**TOWN OF GLASTONBURY**  
GL-2019-16  
**AIR CONDITIONING INSTALLATION AT**  
**GIDEON WELLES ELEMENTARY SCHOOL**  
ADDENDUM NO. 1  
December 20, 2018

**The following drawings, specifications and information are included in this addendum:**

TITLE  
VARIABLE REFRIGERANT VOLUME SYSTEM PIPING DIAGRAM

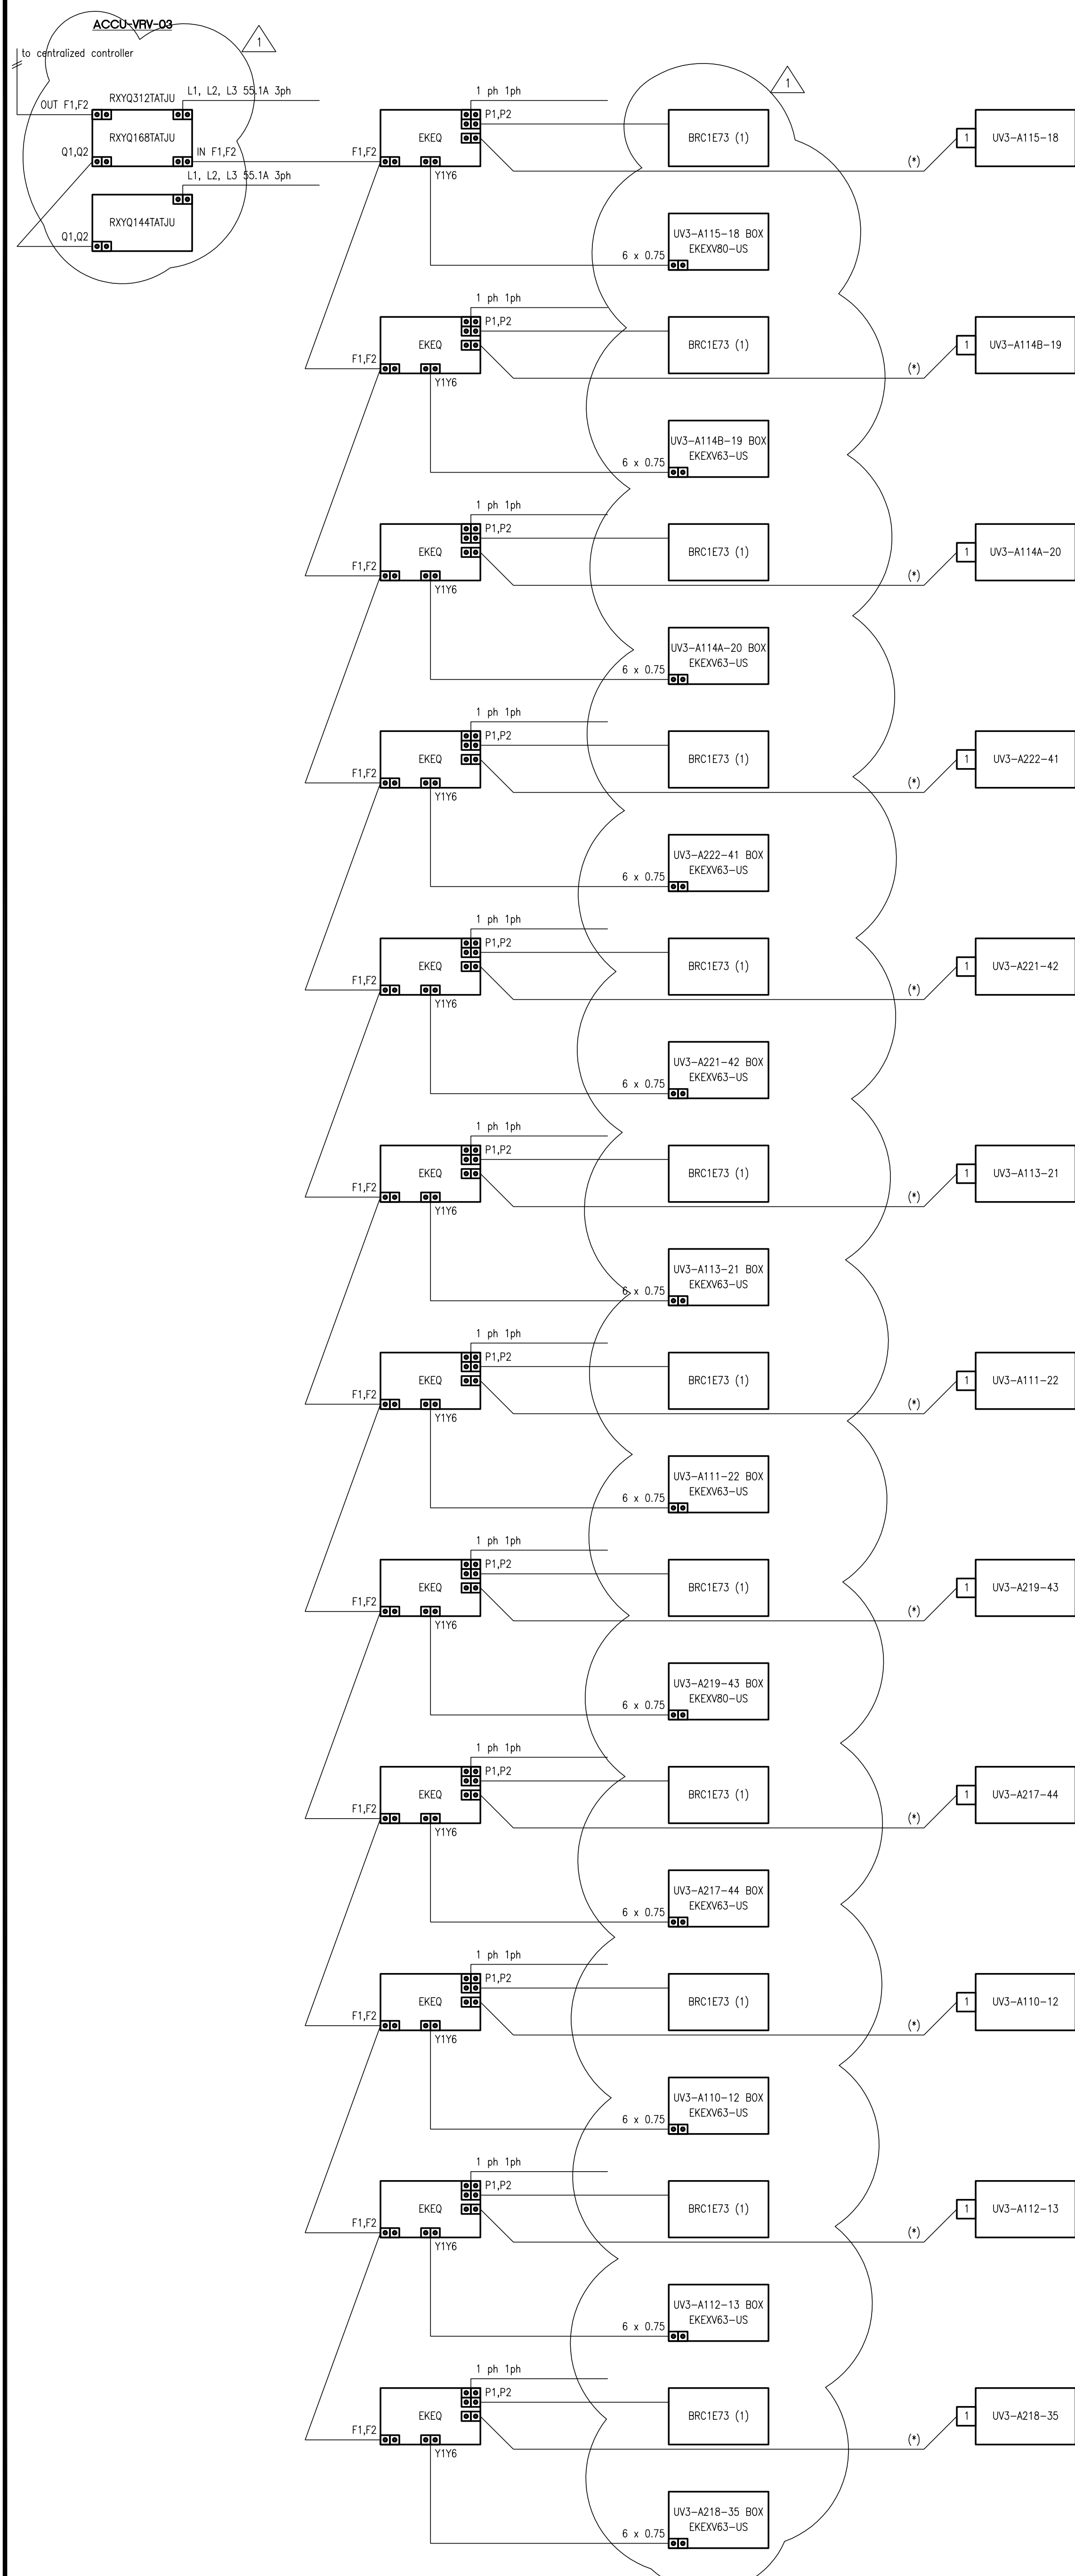
- h. Revise note 10 to read: wood panel to remain.
  - i. Revise note 11 to read: Tall storage cabinet to remain.
  - j. Revise note 15 to read: Existing D/X wall mounted indoor unit (EX-Dx-WIU) shall remain).
  - k. Revise note 17 to read: Existing Air-Cooled Condensing Unit (EX-ACCU) shall remain
  - l. Revise note 21 to read: Clean and disinfect existing Fin-tube radiation.
2. Replace drawing M0.2, dated 11/01/2018 with drawing M0.2 dated 12/17/2018.
  3. Replace drawing M2.0, dated 11/01/2018 with drawing M2.0 dated 12/17/2018.
  4. Replace drawing M3.1, dated 11/01/2018 with drawing M3.1 dated 12/17/2018.
  5. Replace drawing M3.2, dated 11/01/2018 with drawing M3.2 dated 12/17/2018.
